3GPP TSG CN Plenary Meeting #24
2nd – 4th June 2004 Seoul, KOREA.

NP-040214

Source: TSG CN WG4
Title: Corrections on OoBTC Rel-4
Agenda item: 7.7
Document for: APPROVAL

Title:	⌘ Correction to section 6.5 on information flow after UMTS to GSM handover		
Source:	⌘ LM Ericsson		
Work item code:	⌘ OoBTC	Date:	⌘ 27/04/04
Category:	⌘ F	Release:	⌘ Rel-5
	Use <u>one</u> of the following categories: F (correction) A (corresponds to a correction in an earlier release) B (addition of feature), C (functional modification of feature) D (editorial modification) Detailed explanations of the above categories can be found in 3GPP TR 21.900 .		Use <u>one</u> of the following releases: 2 (GSM Phase 2) R96 (Release 1996) R97 (Release 1997) R98 (Release 1998) R99 (Release 1999) Rel-4 (Release 4) Rel-5 (Release 5) Rel-6 (Release 6)

Figure 6.5/1: UMTS to GSM Inter-System Handover

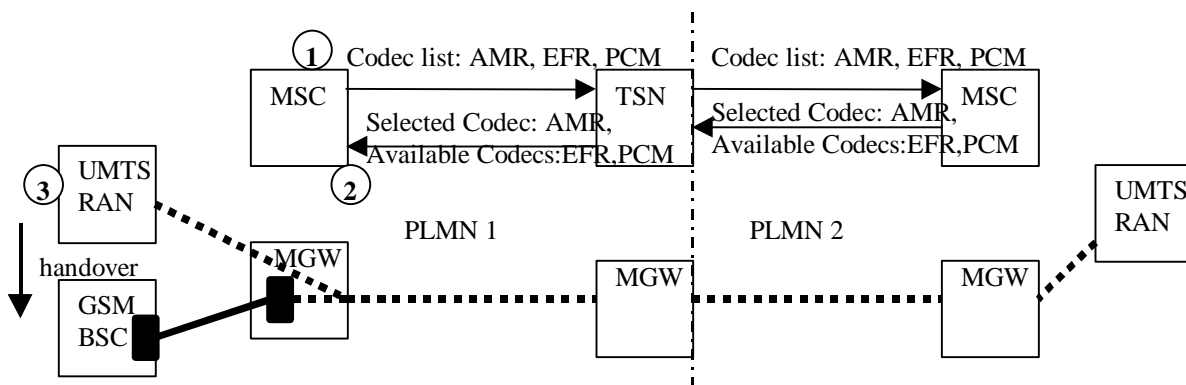
Reason for change:	⌘ Inter-MSC OoBTC signalling has been introduced for handover but there is till text not corrected in section 6.5 that contradicts this. This is an essential correction.
Summary of change:	⌘ Text that states that codec negotiation prior to Inter-MSC handover cannot be performed is corrected.
Consequences if not approved:	⌘ Contradicts text in clause 6.11

In the Intra-MSC case shown in Figure 6.5/1 the MSC controlling the handover has both codec lists for each radio access. The codec negotiation for the UMTS call was performed end to end with UMTS list. If this negotiation resulted in a codec being selected that is also included in the GSM list then at handover the MSC shall indicate this codec as the current speech version to the BSC and TFO can be achieved. If the selected codec is not supported for the GSM radio access but the GSM list contains a codec that is also in the Available Codecs list then the MSC has the option to perform codec modification to ensure TFO can be achieved. The MSC may also perform codec list modification by sending forward the GSM list to update nodes in the network of the change to the Available Codecs List.

If the Inter-system handover is an inter-MSC handover then the Anchor MSC sends the current speech version and the supported speech versions in the Prepare Handover Request message to the MSC-B. If the current speech version (codec selected for UMTS call) is not included in the GSM list then the MSC-A shall indicate a preferred codec in the current speech version parameter. The speech version for the GSM access that is finally selected by the MSC-B's BSS, is returned to MSC-A in the Prepare Handover Response message. The MSC-A can then decide if codec modification or codec re-negotiation shall be performed as described for the intra-MSC case. ~~The MSC-B shall always assume default PCM across the E-interface, as there is no possibility to perform codec negotiation prior to performing the handover.~~ For further details on the inter-MSC signalling see section 6.11. The connections are shown in Figure 6.5/2.
